November 21, 1986

Docket Nos: 50-373  
and 50-374

Subject: Issuance of Amendment No. 47 to Facility Operating License  
No. NPF-11 and Amendment No. 29 to Facility Operating License  
No. NPF-18 - La Salle County Station, Units 1 and 2

FIGURE 6.1-1

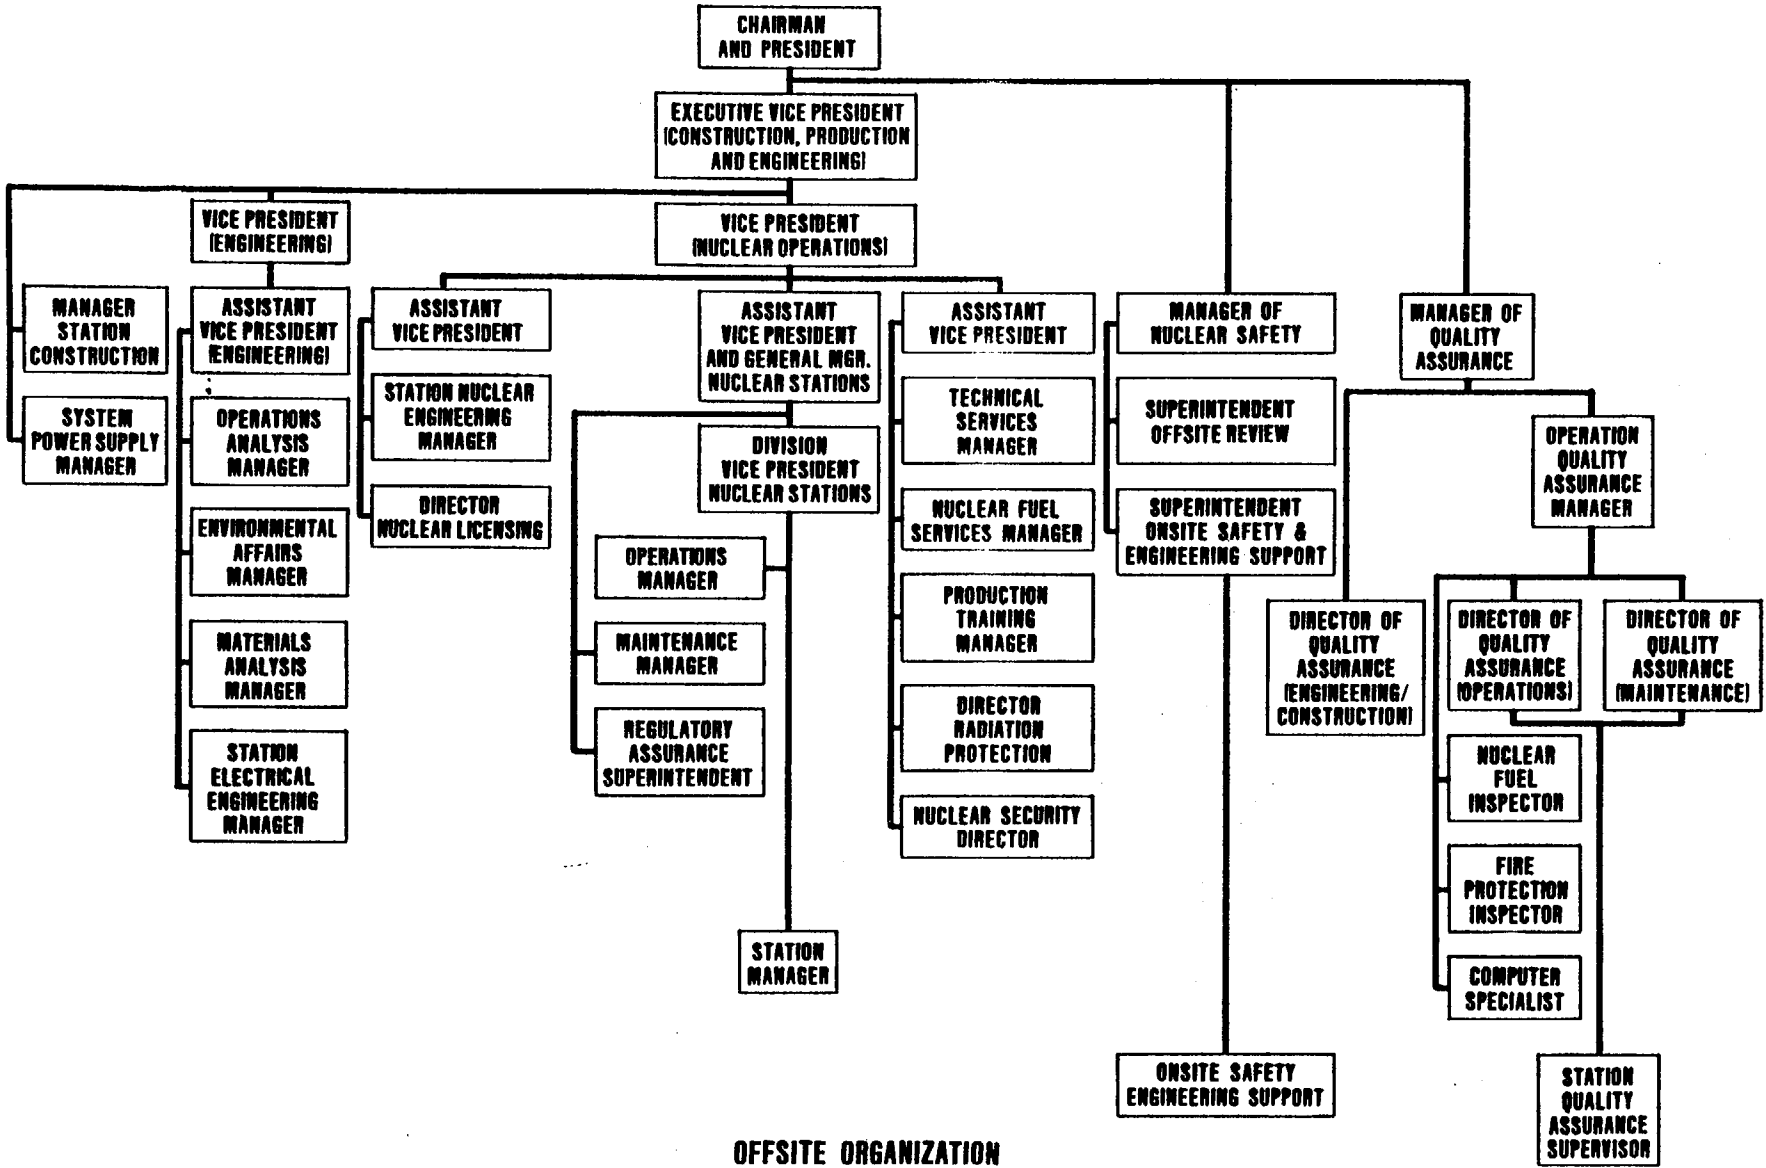
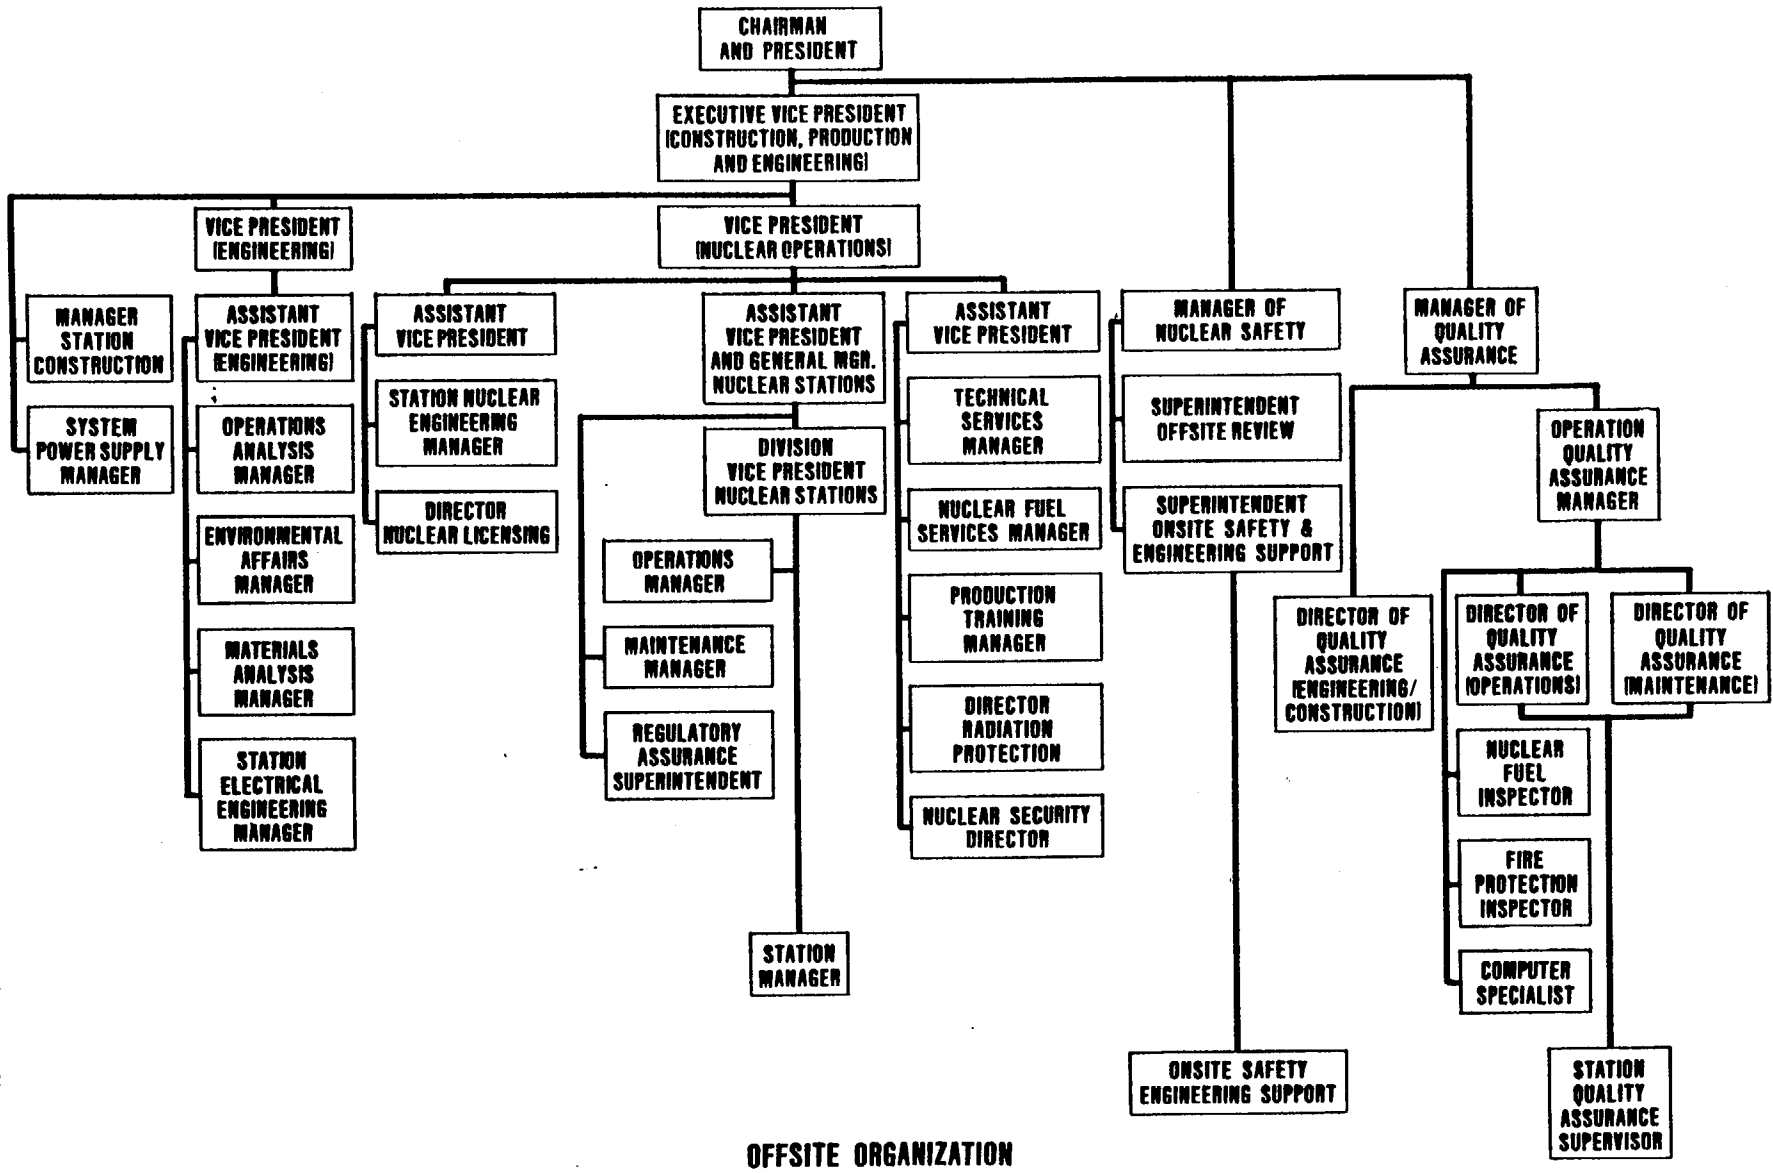
The licensee has proposed to change Figure 6.1-1 to show only those functions that provide technical and management support for La Salle (and the five other nuclear power plants operated by the licensee). Therefore, the following groups have been deleted from Figure 6.1-1:

1. Two Division Vice Presidents Nuclear Stations; one for Dresden, Quad Cities and Zion, and one for La Salle County, Byron, and Braidwood (when completed). These individuals provide direction to the respective Station Managers regarding day-to-day activities and are assisted by an Operations Manager. The Station Manager reports to the respective Division Vice President-Nuclear Stations.

1. The Technical Services Manager has responsibility for providing technical support in the areas of operational chemistry, radioecology, emergency planning, quality control, and fire protection. This position formerly reported to the Division Vice President and General Manager-Nuclear Stations.

A station Electrical Engineering Manager has been added under the Assistant Vice President (Engineering). The Manager of Quality Assurance is now assisted by the Operation Quality Assurance Manager to whom the new positions of Fire Protection Inspector and Computer Specialist report.

Other changes to Figure 6.1-1 are position title changes, deletion of the position of Director Training Program Development, whose functions will be the responsibility of the Production Training Manager, and deletion of positions related to quality assurance during construction.

The staff concludes that the proposed off-site organizational arrangements do not reduce the technical support being provided for La Salle, provide adequate management span of control, are consistent with the guidance provided in NUREG-0731, "Guidelines for Utility Management Structure and Technical Resources" and the acceptance criteria of NUREG-0800, "Standard Review Plan", Section 13.1.1, and are, therefore, acceptable.

FIGURE 6.1-2

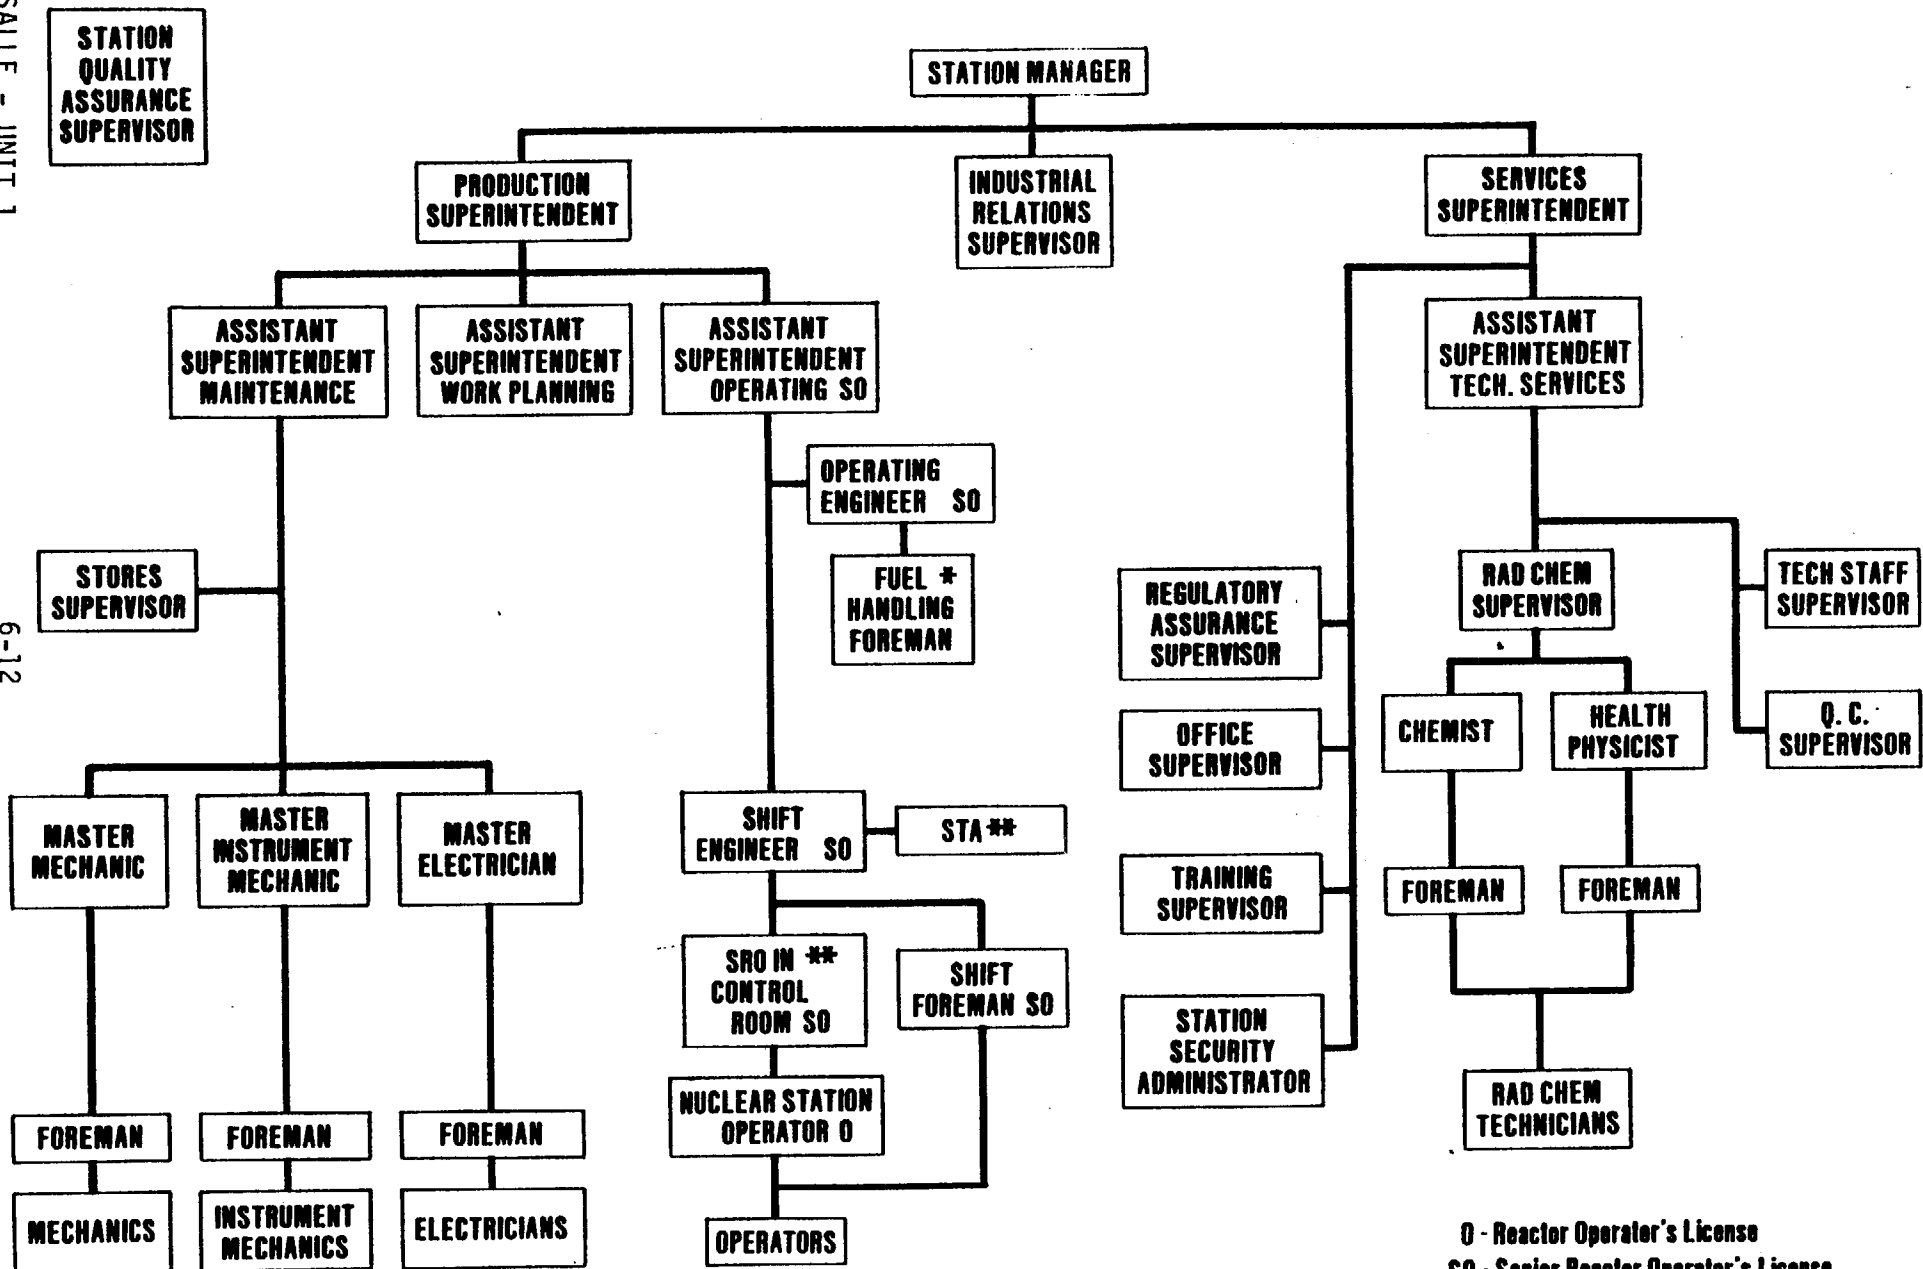
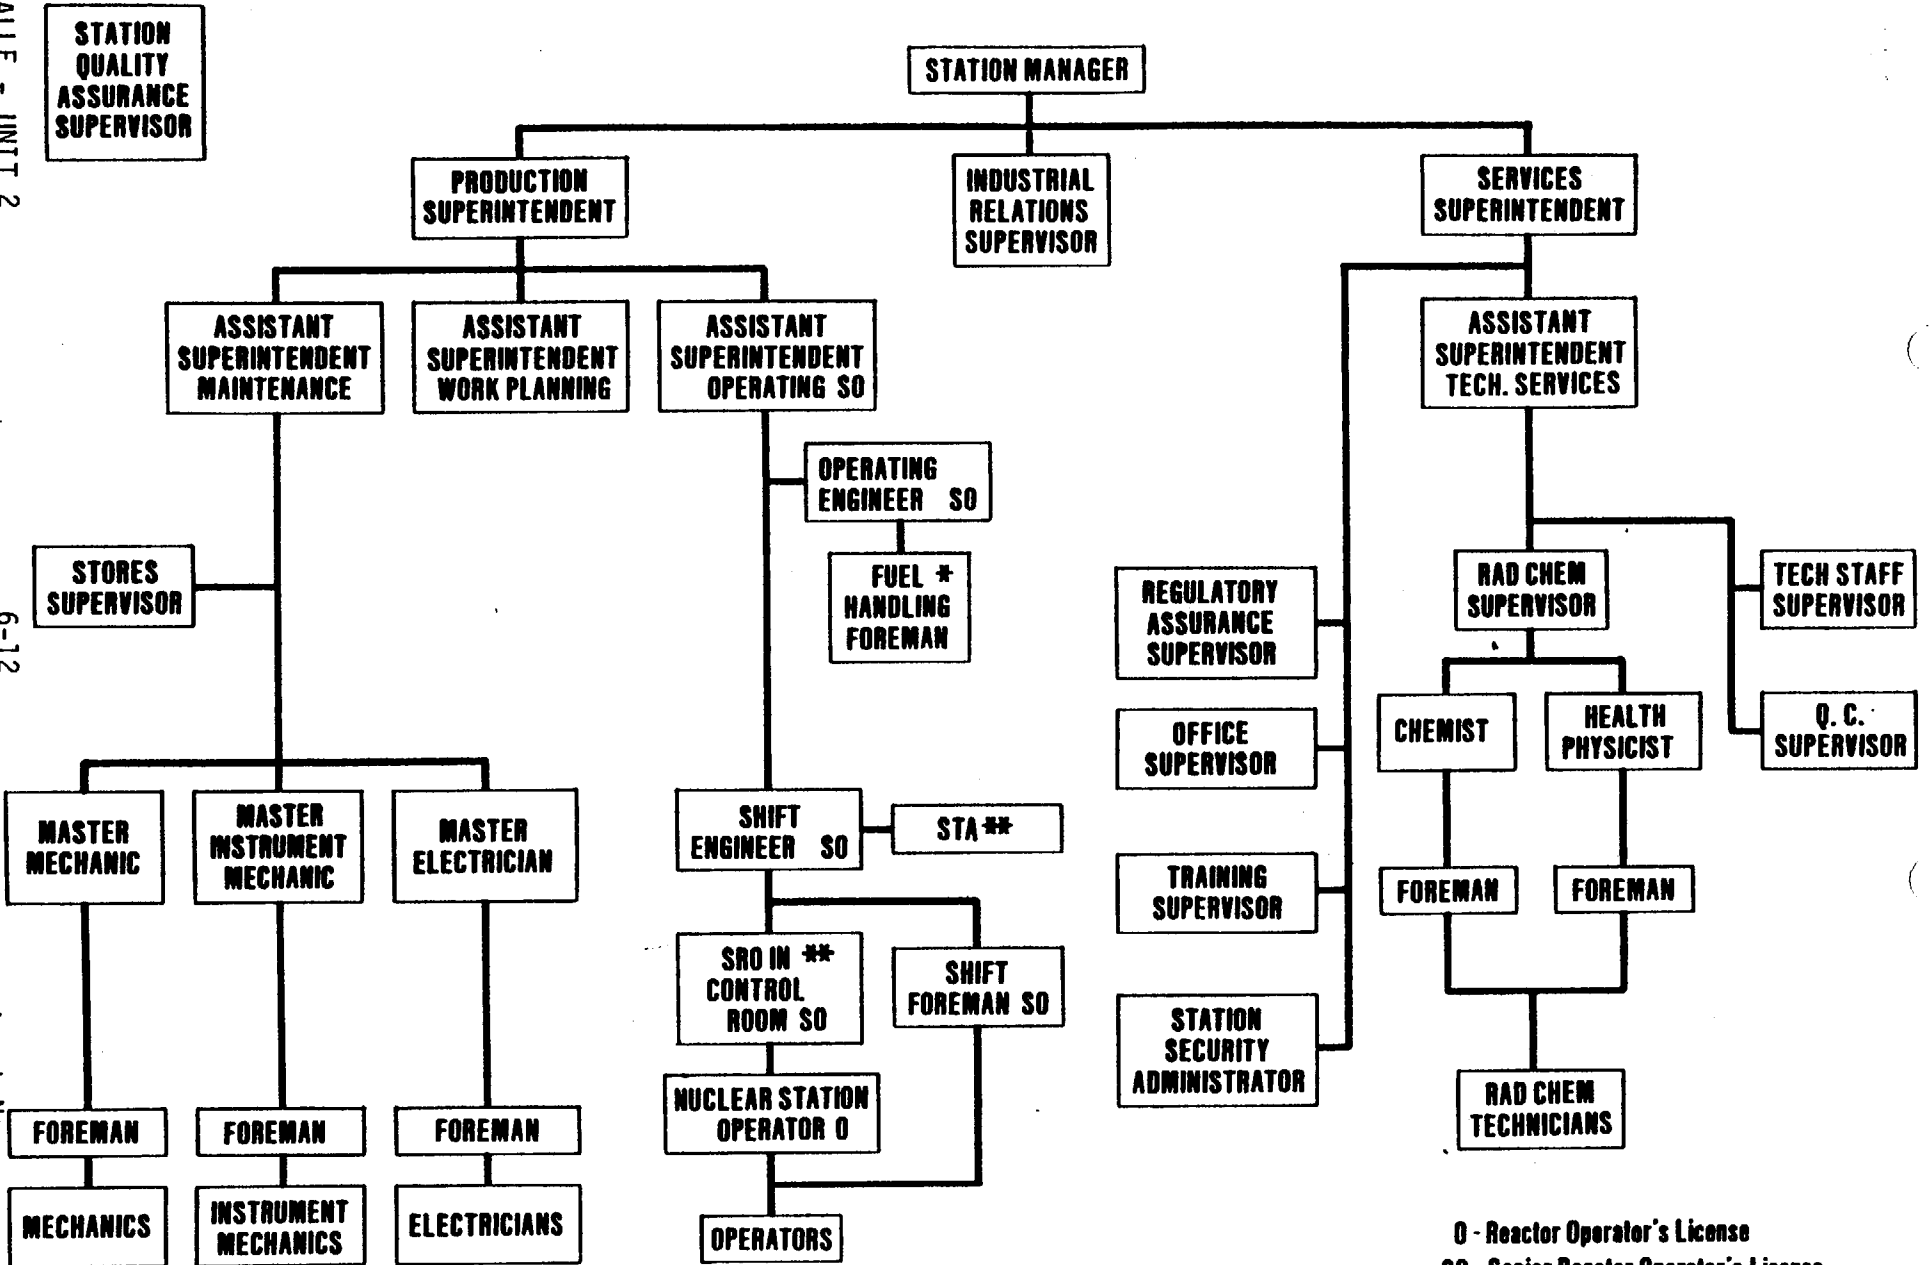
As proposed, the station organization will provide the same functional support for plant operation as has been provided in the past. The principal organizational changes are as follows, and are reflected in the proposed Figure 6.1-2.

Production Superintendent is a new position. This individual manages the day-to-day operating and maintenance activities of the station, both during unit operation and during outages. The Production Superintendent is also responsible for controlling the work of non-station personnel. Reporting to the Production Superintendent are the Assistant Superintendent Operating, Assistant Superintendent Maintenance, and Assistant Superintendent Work Planning. The responsibilities of the Assistant Superintendent Operating and the Assistant Superintendent Maintenance are not changed. Figure 6.1-2 has been clarified to show that the Shift Foreman receives direction from the Shift Engineer and is responsible for supervising the activities of operators outside the control room. Assistant Superintendent Work Planning is a new position that coordinates the work at the station and helps place increased emphasis on work that potentially could affect day-to-day operations.

The Assistant Superintendent Technical Services has responsibility for managing the day-to-day activities of the Technical Staff, Radiation Chemistry, and Quality Control departments. Although the Rad Chem Supervisor reports to the Assistant Superintendent Technical Services, this Supervisor has direct access to the Service Superintendent and Station Manager in order to resolve questions related to the conduct of the Radiation Protection Program. Figure 6.1-2 has been clarified to indicate Chemists and Health Physicists in the Rad Chem Organization.

Other changes to Figure 6.1-2 are position title changes and deletion of some non-supervisory positions.

The staff concludes that the proposed station organizational arrangements are consistent with the guidance provided in NUREG-0731, "Guidelines for Utility Management Structure and Technical Resources" and the acceptance criteria of Standard Review Plan, Section 13.1.2-13.1.3, and are, therefore, acceptable. The staff also concludes, based upon the qualifications and positions in the station organization of the Production and Services Superintendents, that these two Superintendents may authorize, as applicable, deviations to the working hour requirements of Specification 6.1.C.7 as described on page 6-3 of the Technical Specifications.
